Exhaust Manifold Bolts - Sport Jet 120

1995 Sport Jet 120
S/N 0E093700 thru 0E125508

Figure 1

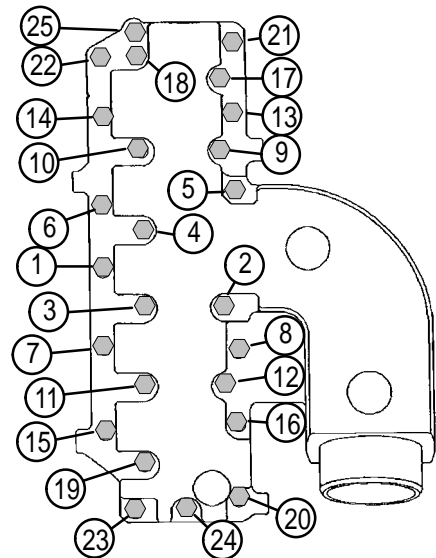
Investigation of this problem revealed reduced (low) clamp load on exhaust manifold gasket. This is caused by initial thermocycling of powerhead which reduced torque of stainless steel bolts.

Engineering has recognized this as an area which needed improvement and developed a new bolt. This bolt has capacity for higher torque and significantly increased clamp loads.

NOTE: It is very important to oil bolt threads and underside of head prior to installation to achieve proper and uniform clamp load.

1. Remove bolt #1 per Figure 1. Install new bolt and existing washer. Torque bolt to 115 lb/in (13.0 N·m). Then, follow same procedure for bolt #2 and so on until all bolts have been replaced and torqued following the sequence in Figure 1.

2. After all bolts have been replaced and torqued, retorque bolts #1 thru #8 (center bolts) per Figure 1.
